**Subject: Seismic Assessment of the South Emergency Operations Center
26081 Via Pera, Mission Viejo, CA 92691**
IDS Job Number: 17S020

Per your request, IDS Group, Inc. (IDS) has performed a seismic assessment of the South Emergency Operations Center (EOC) for the Water Emergency Response Organization of Orange County (WEROC) located at 26081 Via Pera in Mission Viejo, California. This letter presents our opinions, observations, and conclusions based upon our assessment.

Figure 2: Layout of Lateral Force Resisting System

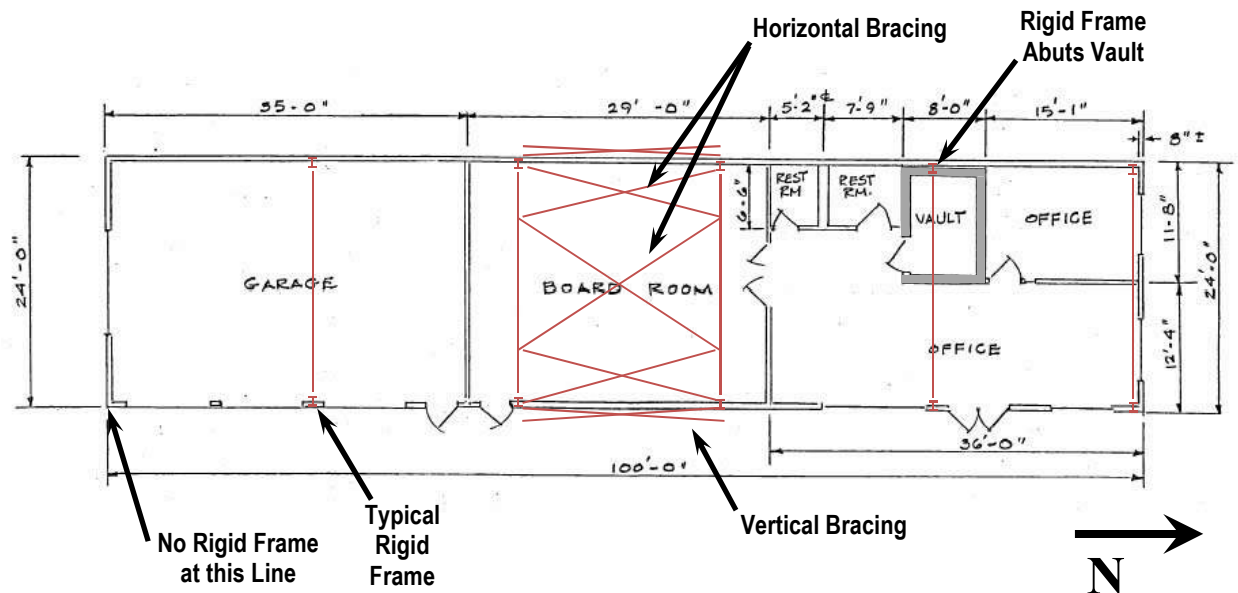
The building's lateral force resisting system [shown in Figure 2] includes one bay of horizontal tension-only rod bracing at the middle of the building for resisting forces in the longitudinal direction. That bracing is intended to collect lateral forces from building elements and transfer them to the east and west sides of the building where vertical tension-only strap bracing is connected to the building's frame columns. This strap bracing then transfers the lateral forces down to anchor bolt connections at the bases of rigid frame columns for transfer to the concrete slab on grade foundation. In the transverse direction of the building, five regularly spaced rigid frames serve to collect and resist the building's lateral forces. These rigid frames have bolted beam to column connections and pin-based columns with anchor bolts that transfer the lateral forces to the concrete slab on grade foundation.

- Incomplete Lateral Force Resisting System – The building framing and structure does not provide a complete system for collecting and resisting lateral forces. In the longitudinal direction, horizontal bracing is only provided across one bay. For both directions, there is no complete means of collecting the seismic forces from the various building elements and conducting those forces to the elements of the lateral force resisting system. At the south end of the building, there is no rigid frame for resisting forces in the transverse direction. The lack of this frame is anticipated to lead to greater damage at the building's south end as well as at its southernmost rigid frame.

- Insufficient Lateral Force Resisting System – Nearly all the lateral force resisting system elements provided are insufficient to resist the anticipated lateral forces required by the current Code. This statement encompasses the entire load path from the horizontal and vertical braces to the rigid frames as well as the system connections.

1. Complete the Seismic Force Resisting System – Many new seismic force resisting system elements including a diaphragm, collectors, and connections would need to be added.

2. Strengthen the Seismic Force Resisting System – Weak or insufficient elements of the existing system would need to be strengthened to resist current code forces.

Photo 15: Cracking at Concrete Slab in Garage

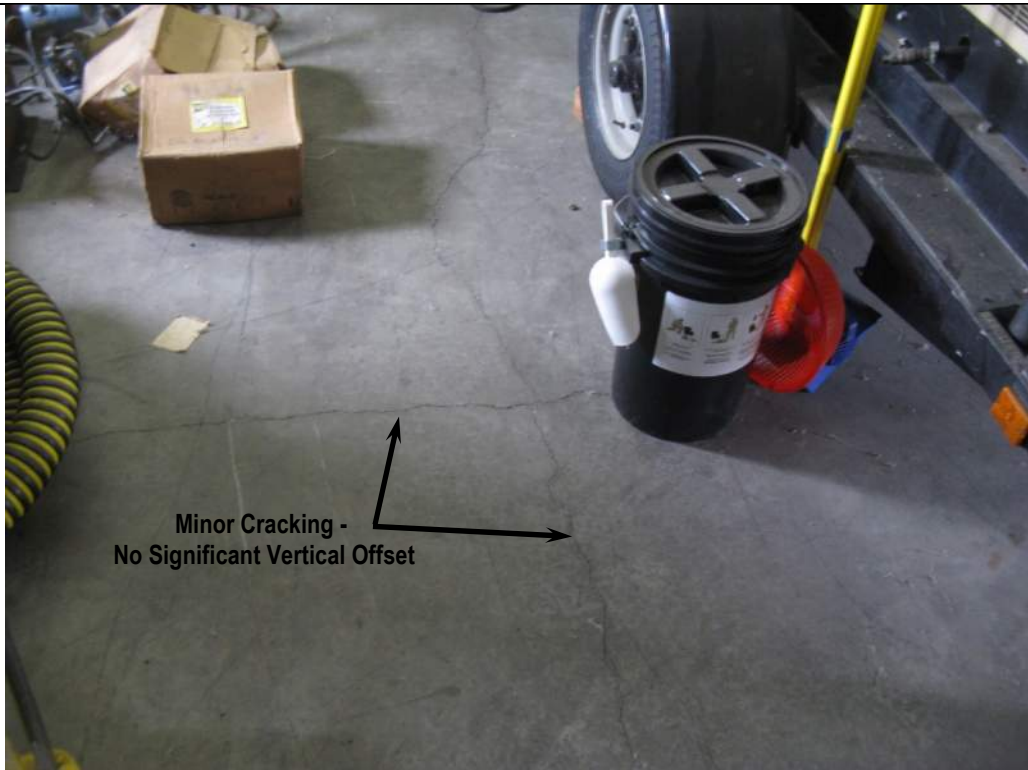
- Concrete Slab Damage – The majority of the concrete slab on grade was covered by carpeting or other floor finishes and so was not open to view. However, the slab in the garage area at the south end of the building was bare and open to view. In this area, we observed some linear cracking that did not appear unusual for slabs of this type with its existing joint spacing [Photo 15]. We also observed one location at the front of the garage where the concrete slab has cracked between the door jamb anchors and the slab edge [Photo 12]. A small area (approximately 2 feet long) of deterioration of an exposed slab edge on the west side of the building was also observed. The corner of the concrete in this area appears to

5. Repair Damaged or Deteriorated Building Elements – Where damage or deterioration exists, we recommend repairing the elements to prevent or reduce future or ongoing damage and deterioration.

Photo 18: Rigid Frame Abutting Masonry Vault

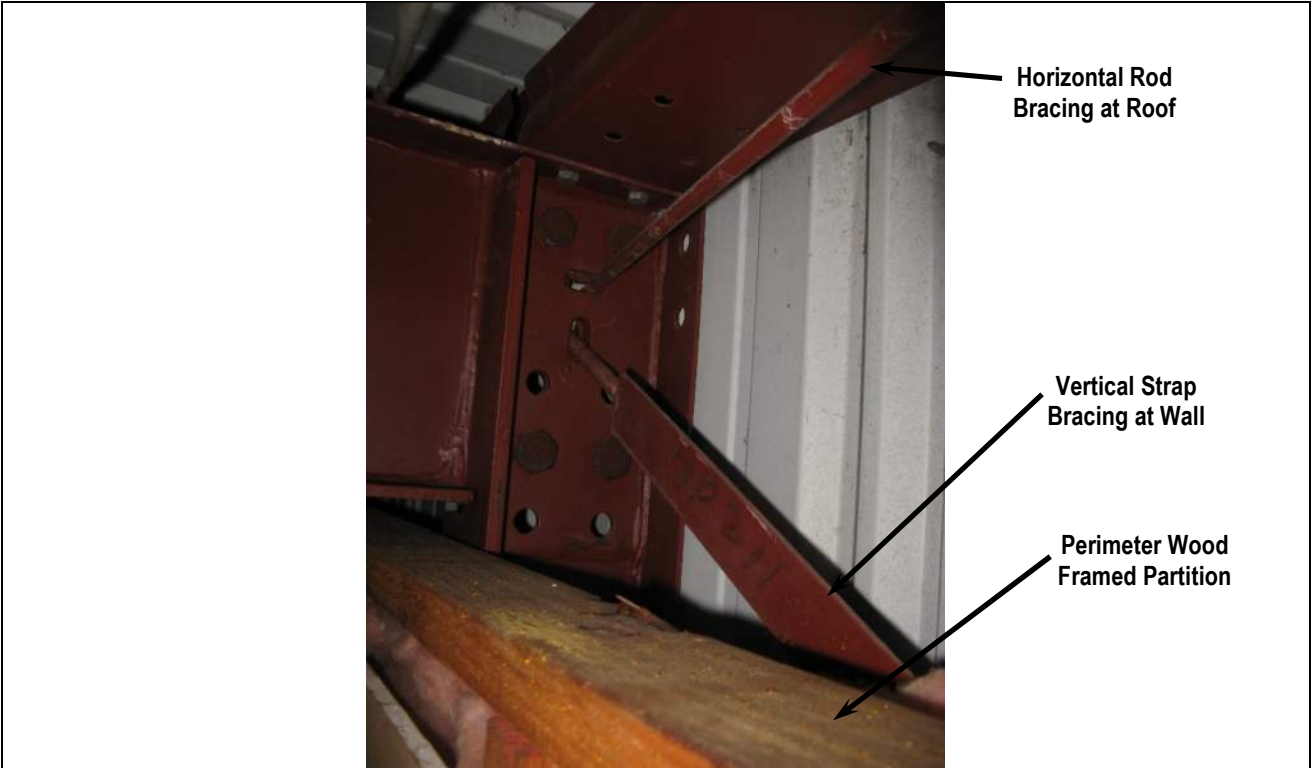
- Adjacent Structures– The concrete masonry vault structure inside the building is located adjacent to the first interior frame from the building's north end. There is insufficient gap between these two elements to prevent unintended interaction [Photo 18].

3. Provide Seismic Separation at Masonry Vault – The masonry vault is a rigid element that will have almost no seismic movement relative to the surrounding building frame. Adequate separation of these elements is necessary to prevent damage to the building frame system.

Photo 19: View of Above Ceiling

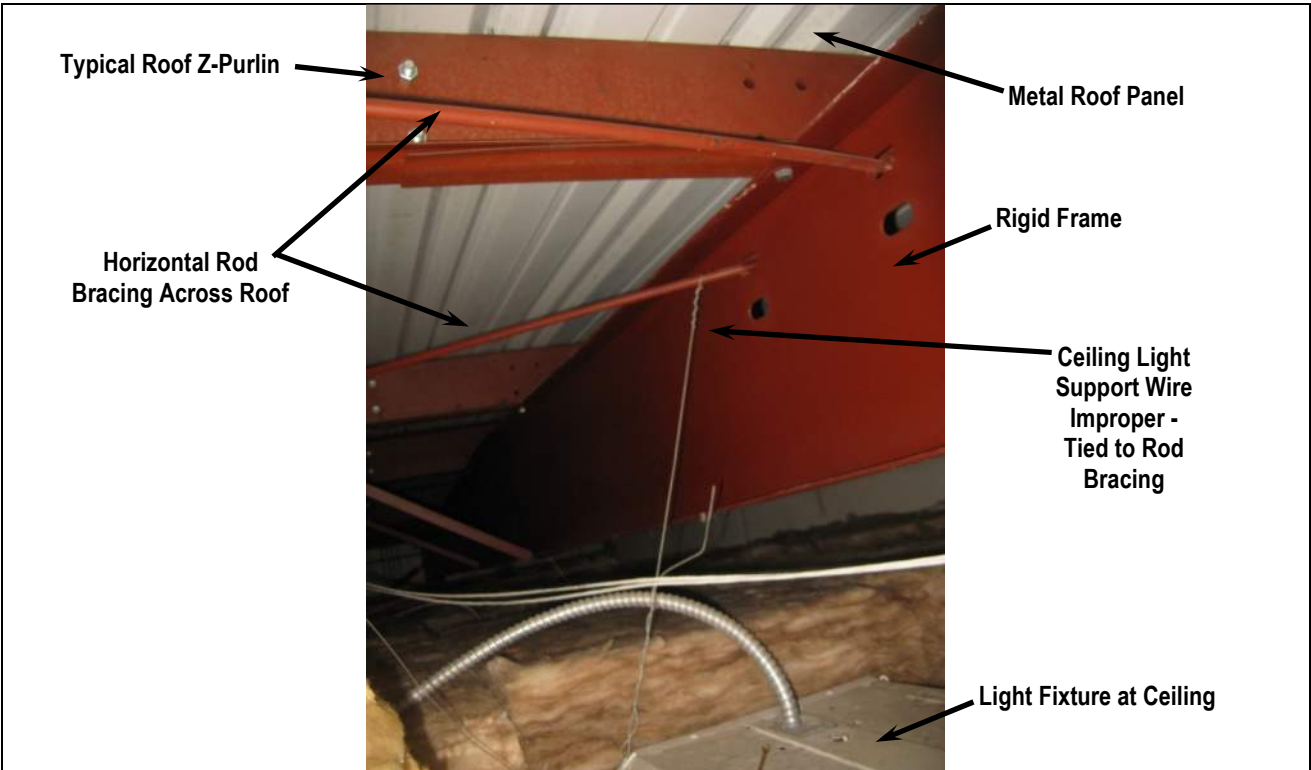
- Non-compliant Ceiling – The ceilings were observed to be supported and braced with undersized wires (0.0625-inch diameter instead of 0.106-inch diameter), to not have compression bracing, and to have wires without proper connections or wrapping. Perimeter ceiling support angles were also observed to be too small and irregularly anchored to

properly support the ceiling grid [Photos 19, 22 to 24]. The grid near the south exterior door to the EOC room was also observed to have several panels that were loose close to falling from the grid [Photo 27].

4. Anchor Non-Structural Elements and Equipment – Anchorage and bracing of non-structural elements and equipment is necessary to prevent or reduce falling objects and potential damage to equipment necessary for emergency operations.

Photo 29: Loose Attachment of Partition Braces

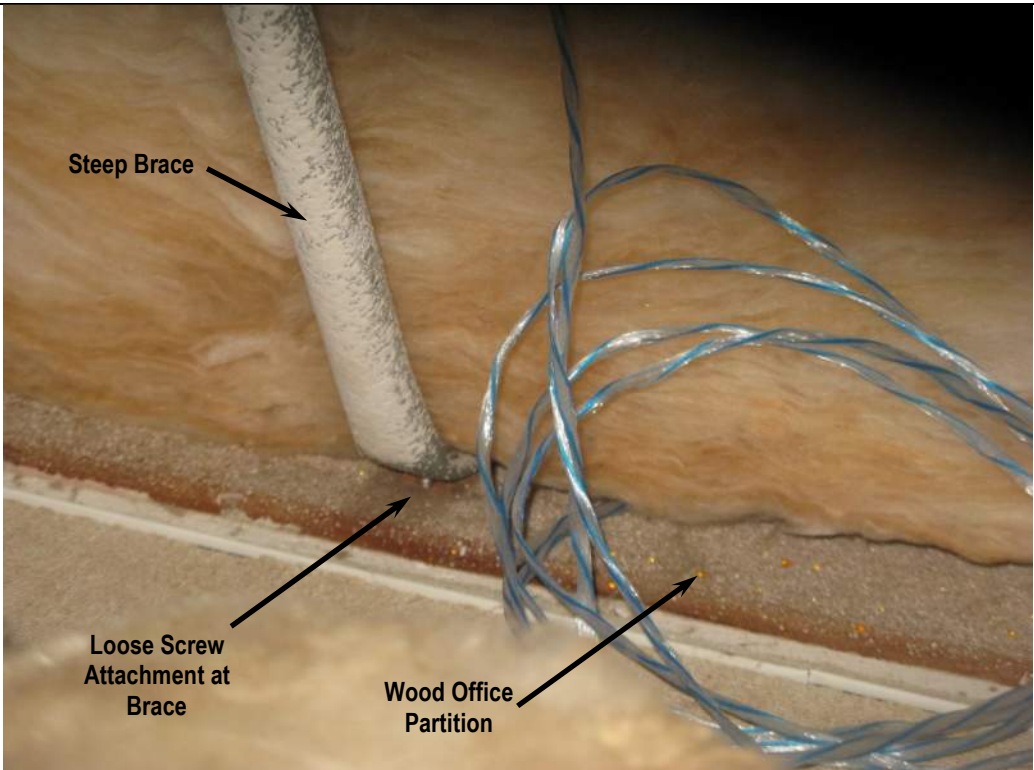
- Interior Partition Bracing – Interior partitions were observed to have steep bracing to z-purlin members at locations without blocking or stability bracing. [Photos 28 and 29]. Along the perimeter of the building, the partitions appeared to be anchored and braced at their mid-height to the exterior wall wind girt members [Photo 30]. These partitions did not appear to have bracing at their top.

Photo 37: Map Support Hanger in EOC

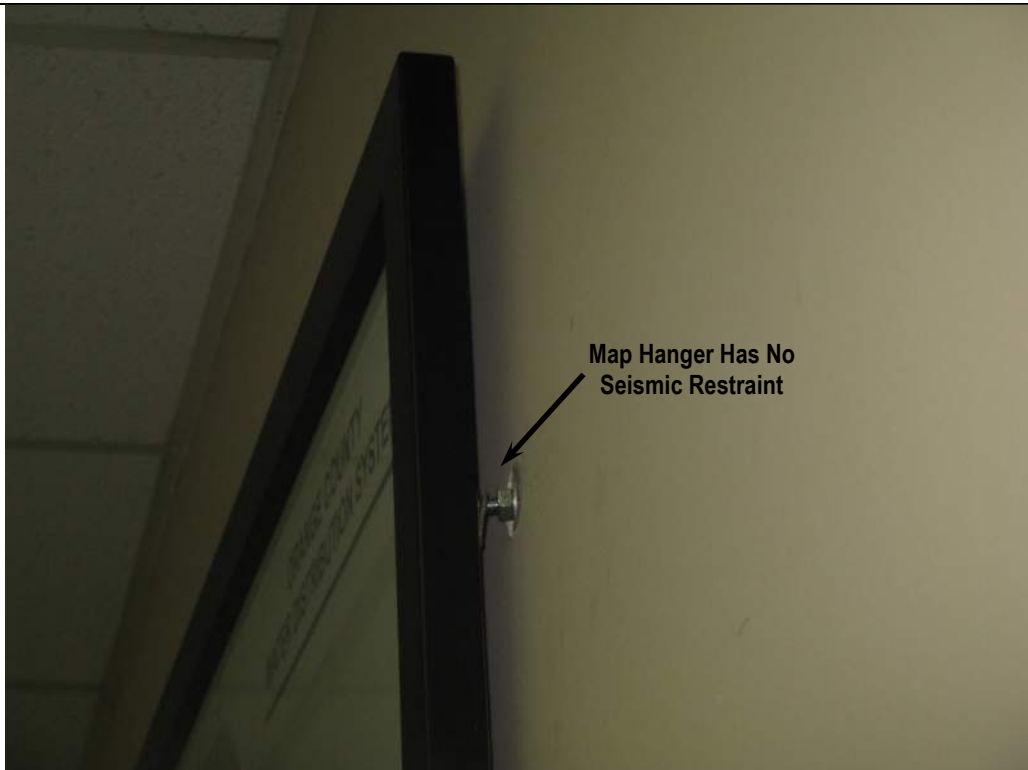
- Contents Not Anchored – A tall and narrow book case was observed to not be anchored although restraint angles were present at its top [Photos 35 and 36]. Several maps in the EOC room were observed to have support clips without sufficient seismic restraint [Photo 37].
